STONE GATE SUBDIVISION, 1st, 2nd, AND 3rd

ADDITIONS

APPLICATION NUMBER 17 DATE March 17, 2005

REQUEST Subdivision

DETAIL SITE PLAN

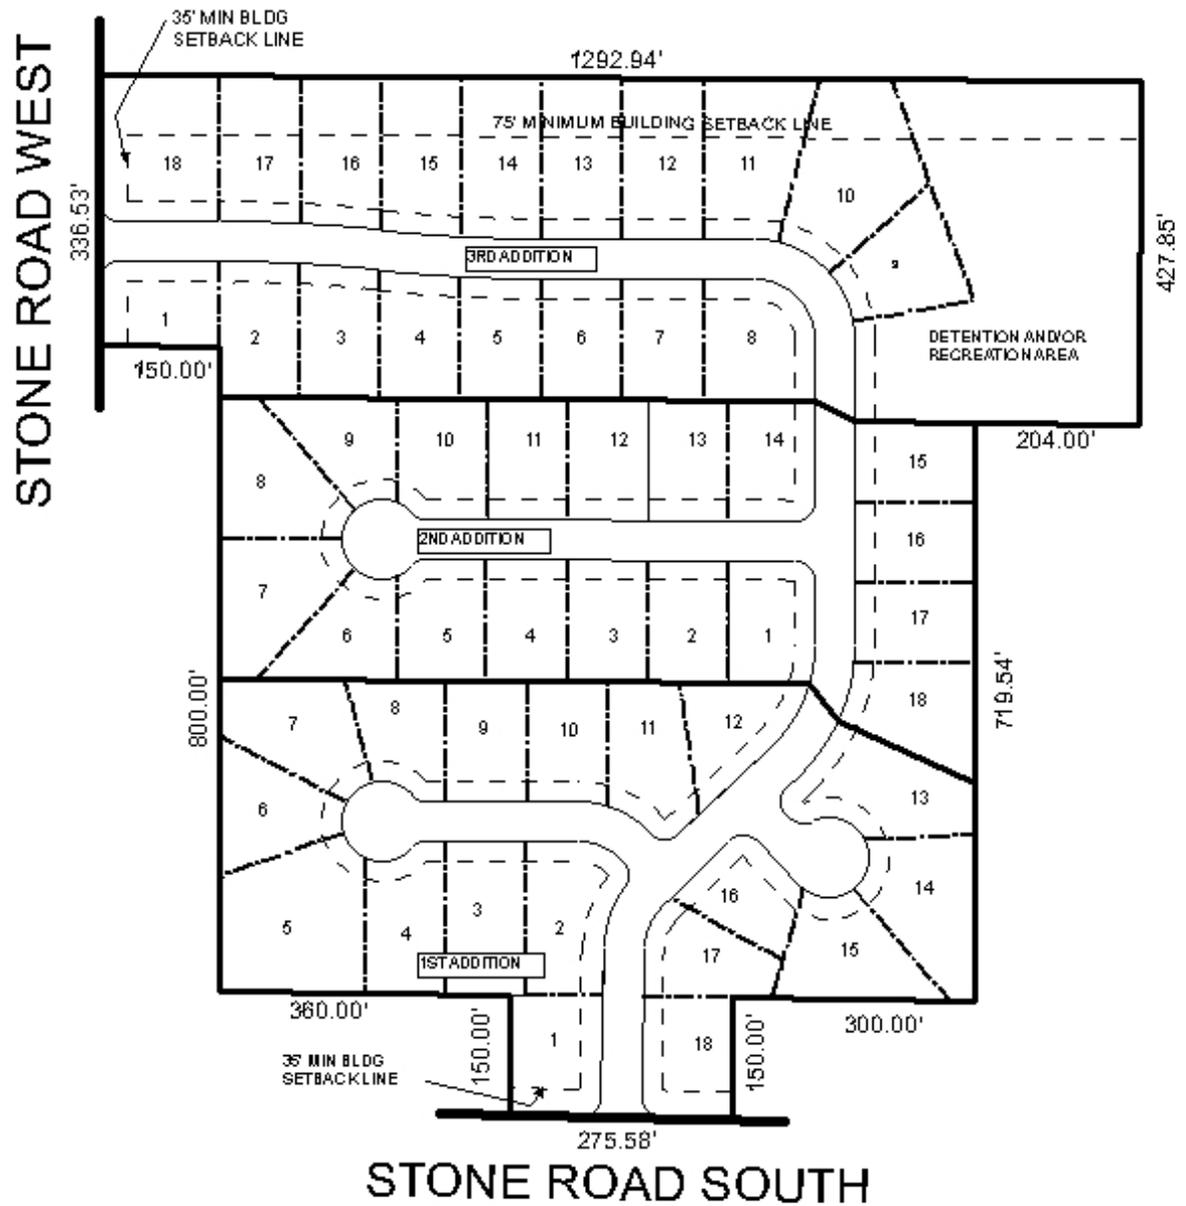
The plat was granted Tentative Approval in 1999, and only one unit was recorded; thus the approval has expired. The plat provides two points of access for the proposed lots, one each to Stone Road West and Stone Road South. The plat also depicts a 75' setback from the future major street (Eight Mile Creek Parkway), which runs along the North boundary of the Subdivision; this would provide for a 25' building setback, as well as the needed 50' right-of-way from the centerline. Access management is a concern; thus the placement of a note should be required on the final plat, stating that direct access is denied to Eight Mile Creek Parkway for Lots 10-18 (3rd Addition).

Common areas are shown on the plat as being either for detention or recreation; thus the placement of a note should be required on the final plat, designating the common area for detention or recreation, and stating that maintenance thereof shall be the responsibility of the property owners.

The site is located in the County; thus any lots that are developed commercially and adjoin residentially developed property must provide a buffer, in compliance with Section V.A.7 of the Subdivision Regulations.

The plat meets the minimum requirements of the Subdivision Regulations and is recommended for Tentative Approval, subject to the following conditions: 1) the placement of a note on the final plat stating that direct access to Eight Mile Creek Parkway is denied for Lots 10-18 (3rd Addition); 2) the placement of a note on the final plat designating the common area for detention or recreation and stating that maintenance thereof shall be the responsibility of the property owners; and 3) the placement of a note on the final plat stating that any lots that are developed commercially and adjoin residentially developed property must provide a buffer, in compliance with Section V.A.7 of the Subdivision Regulations.
